INVESTIGATIONS OF THE HYDRAULIC
PROPERTIES OF THE REVISED HOWELL-BUNGER
VALVE - CITY OF SEATTLE, WASHINGTON

Hydraulic Laboratory Report No. 168

Subject: Investigations of the hydraulic properties of the revised Howell-Bunger valve, City of Seattle, Washington.

FIGURE 1

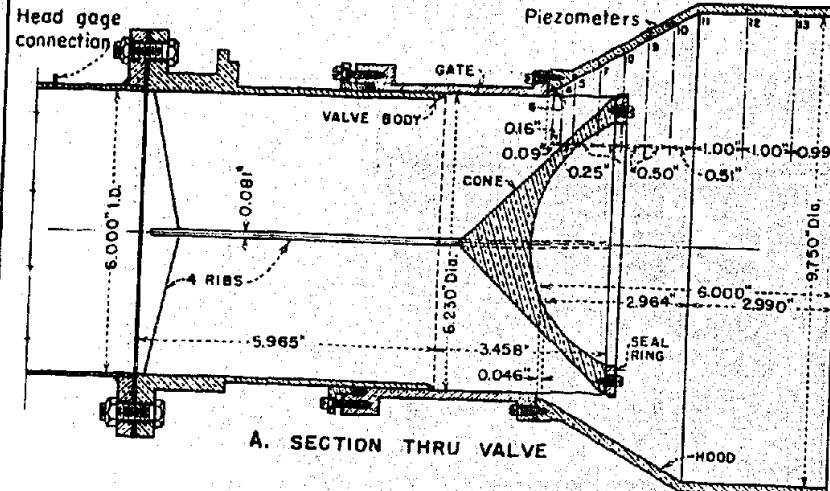
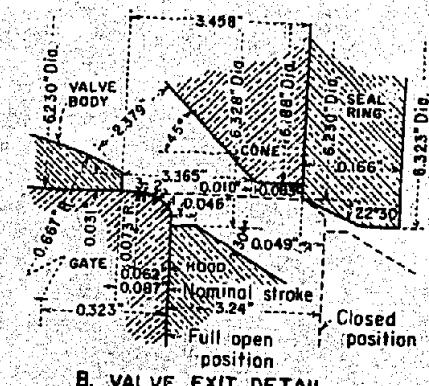
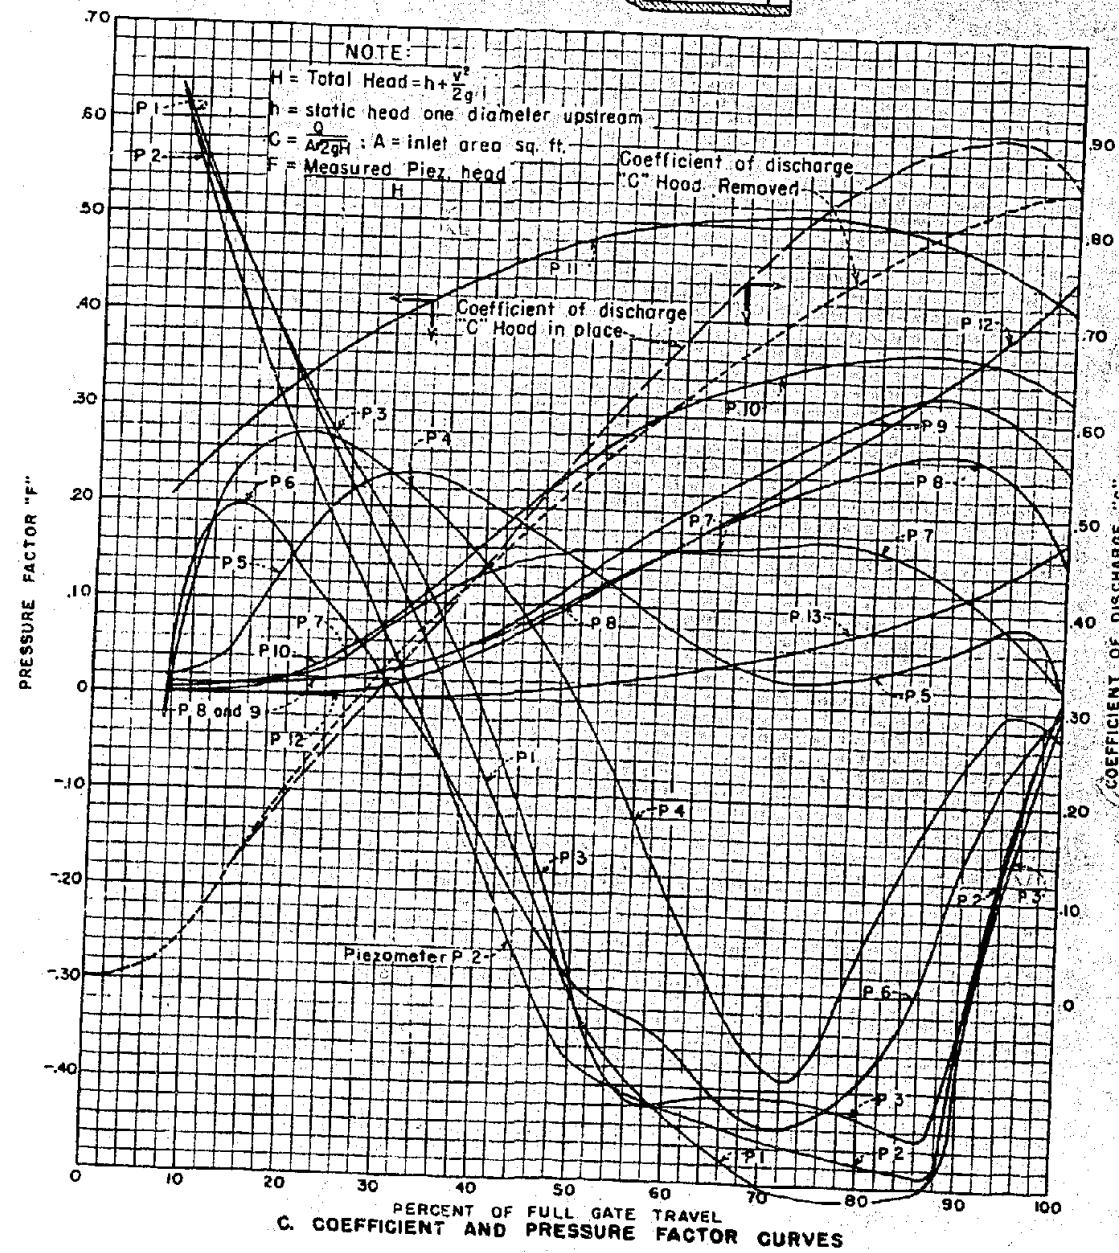
6. Conclusions. As far as could be determined from the model, it appears that positive pressures will exist on all parts of the valve for free discharge without the hood attached. It was not possible to obtain pressures on the 0.667-inch radius at the downstream end of the valve body, figure 1B. It cannot be stated that positive pressures will exist on this part of the valve.

FIGURE 3

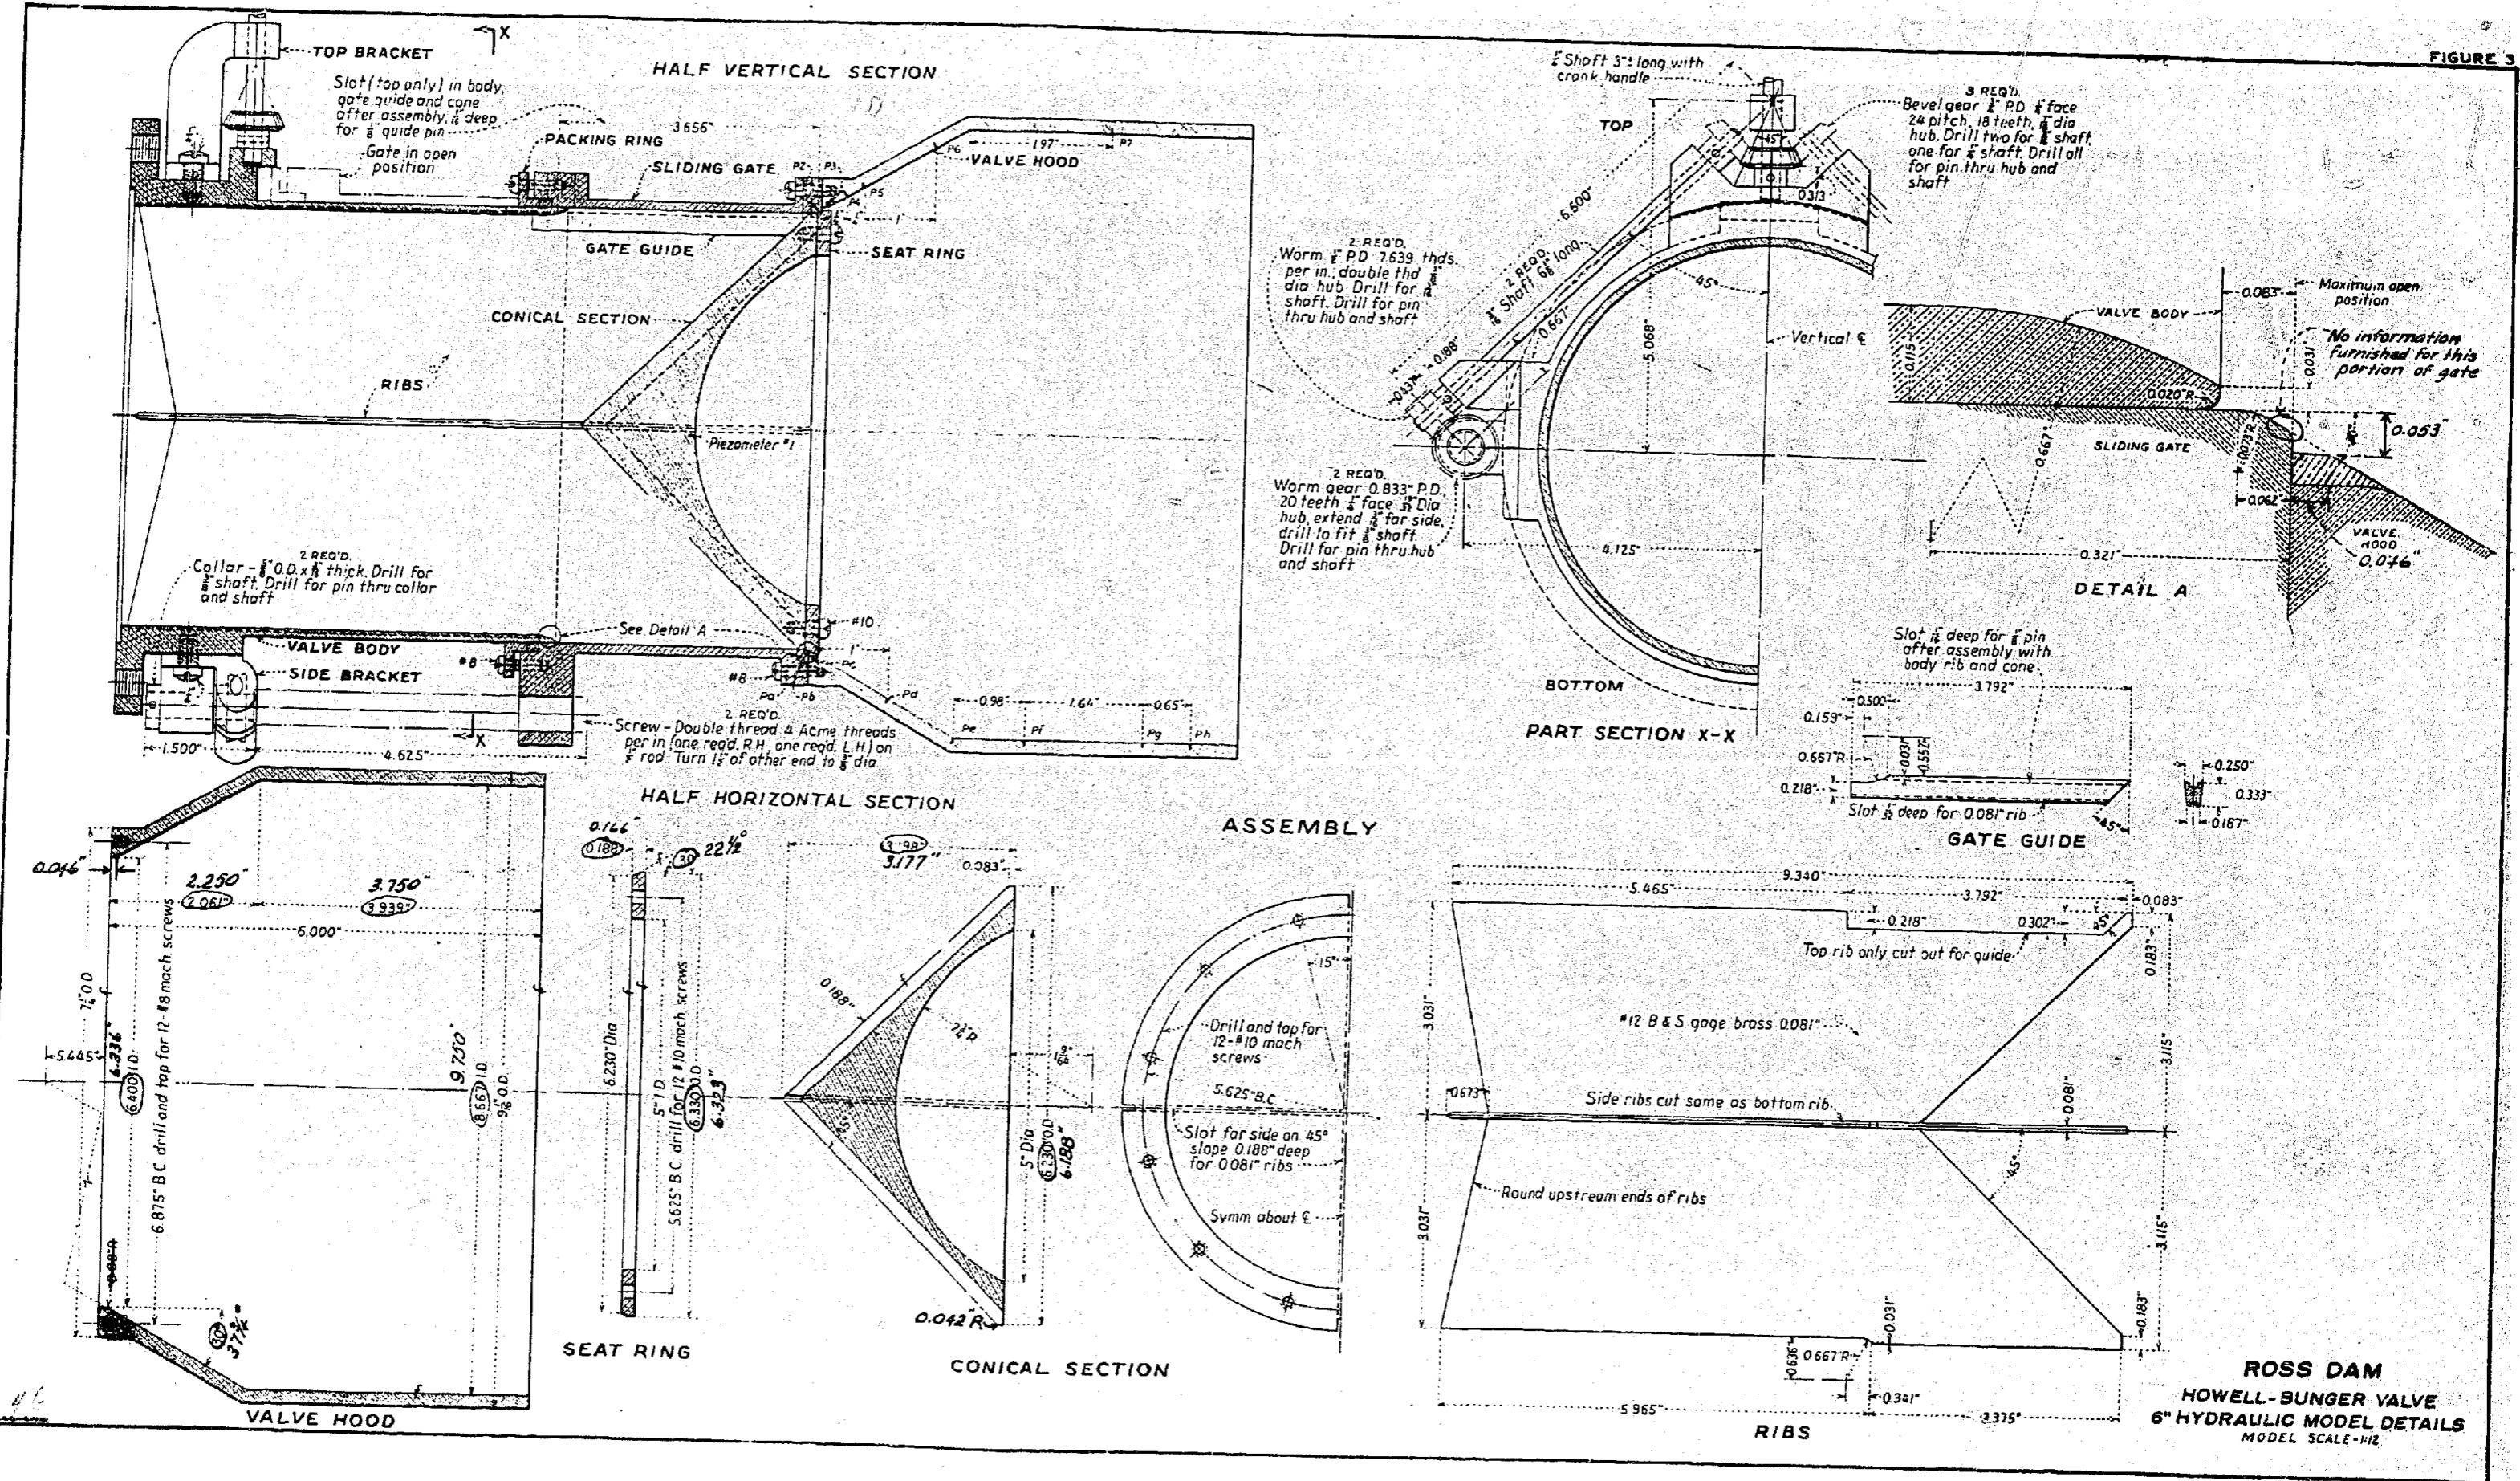
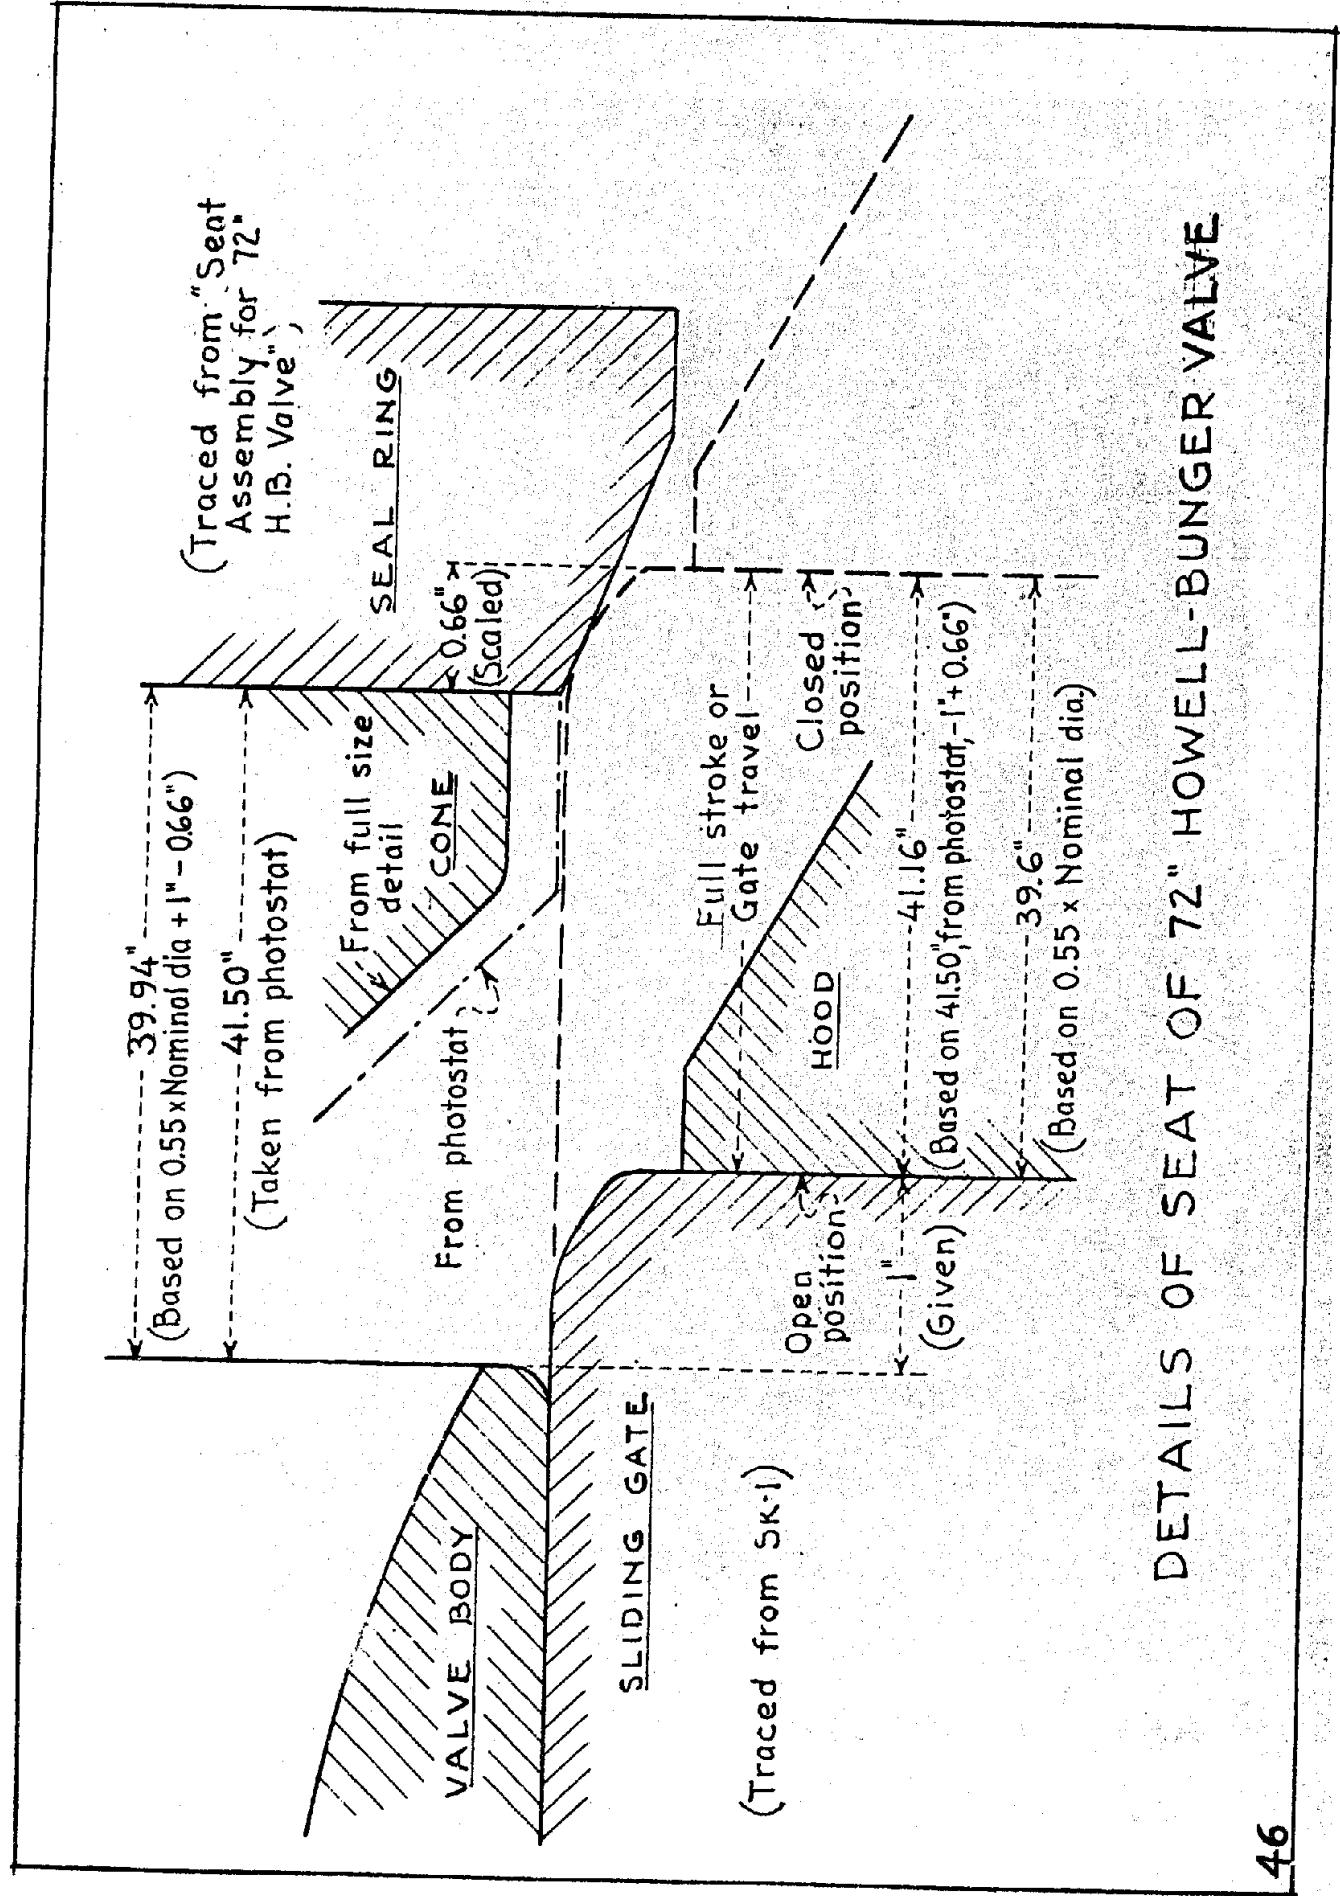
Referring to your drawing Figure 3, you will note that we have checked your figures in red and made several corrections. On the cone, we believe it unnecessary to reduce the diameter to .616" for the new test, as it will not affect the discharge with a larger hood of proper dimensions, as occurred before with the incorrect hood diameter. The radius of the cone as per detail A of .073" should be drawn to intersect with the end of the gate and should not be tangent to the 30° line. The center of the radius is correctly shown.

The cone angle of the valve hood should be 30° as corrected.
